**CAG MEETING #1 SUMMARY NOTES  
AND AGENDA**

## Windjammer Park Integration Plan Community Advisory Group Meeting 1 Summary

Wednesday January 20, 2016

Preferred concept / draft plan

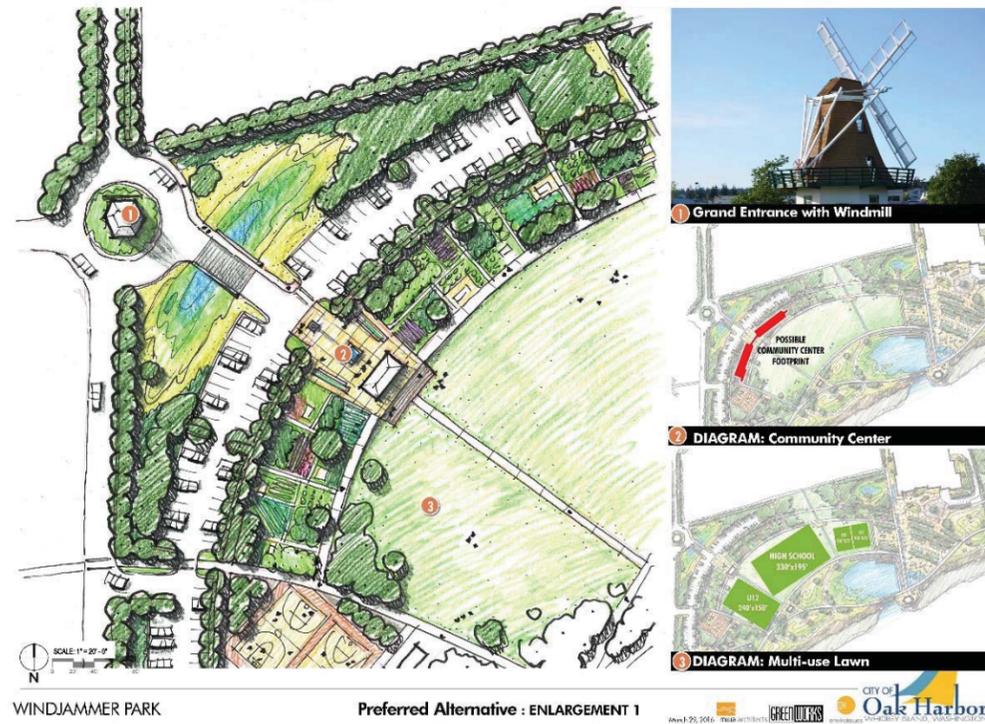
Name	On a scale from 1-5, how well has the draft plan incorporated your feedback?	Why do you feel this way?
Karla Freund	5	“The design team incorporated everything that was discussed and I approve of the windmill placement. The park has a good flow.”
John Fowkes	4.5	“This park looks like a neat place to hang out for the weekend but there feels like something is missing. Overall the feedback has been incorporated.”
Franji Christen	4	“Pleased at how the design team has listened and incorporated feedback including the relocation of the windmill, lagoon, and open spaces. Can City Beach Street turn right and not have the street on the west side of the park?”
Mike Wright	4	“Concerned about parking on the east side and may create problems with condos and increased park traffic. Concerned about kitchens, bathroom placements, and wetlands.”
Jes Walker-Wyse	4	“Approve of the windmill placement. Still absorbing the overall plan.”

Skip Pohtilla	4-4.5	"Concerned about access and parking but approve of the idea of moving the windmill so it is visible from HWY 20 to draw people to park. Concerned about landscape maintenance and issues, may replace with some art or shade trees that may not need as much maintenance. For beach access, dunes could be replaced with a manmade beach above high tide, similar to what was done in Vancouver."
Jon Phillips	5	"Like the increase of trails, natural design, the dunes as natural windbreaks, and understand that by pulling picnic spaces away from beach, maintenance can be reduced. Approve of parking throughout park, promenade with splash park and defined terminus will be the defining point for the park."
Erik Mann	4-4.5	"Not fond of the dune concept and reduction of open space in the park as this area will require more maintenance and take away views of the park. Windmill relocation is a plus and approve of the event space."

Cheryl Leuder	4	"I understand that the ballfields and RV Park aren't included. I approve of the windmill relocation but dislike the road nearest the condos due to light pollution and traffic impacts."
Kristi Krieg	4	"I understand that change is hard and ballfield removal is difficult to imagine. I understand it won't meet everyone's needs but seems to meet the needs discussed."
Ferd Johns	5	"Great plan, turns the corner on downtown and moving away from vehicular to pedestrian. Takes advantage of the waterfront and park visitors will have a variety of activities and a lot of different experiences."
Hal Hovey	4	"Like the potential windmill relocation. Don't like the west side of the lagoon, the dunes, the east-end parking and street. This does not seem like an easy concept to build incrementally."
Dave Goodchild	4	"How often is the kayak campsite being used by the general public? The dune landscape is interesting. In terms of park architecture, what is the park's character or theme? Will it be Dutch or reference Deception Pass? Concerned with rentable space management at City level and appearance of gardens during off-season."
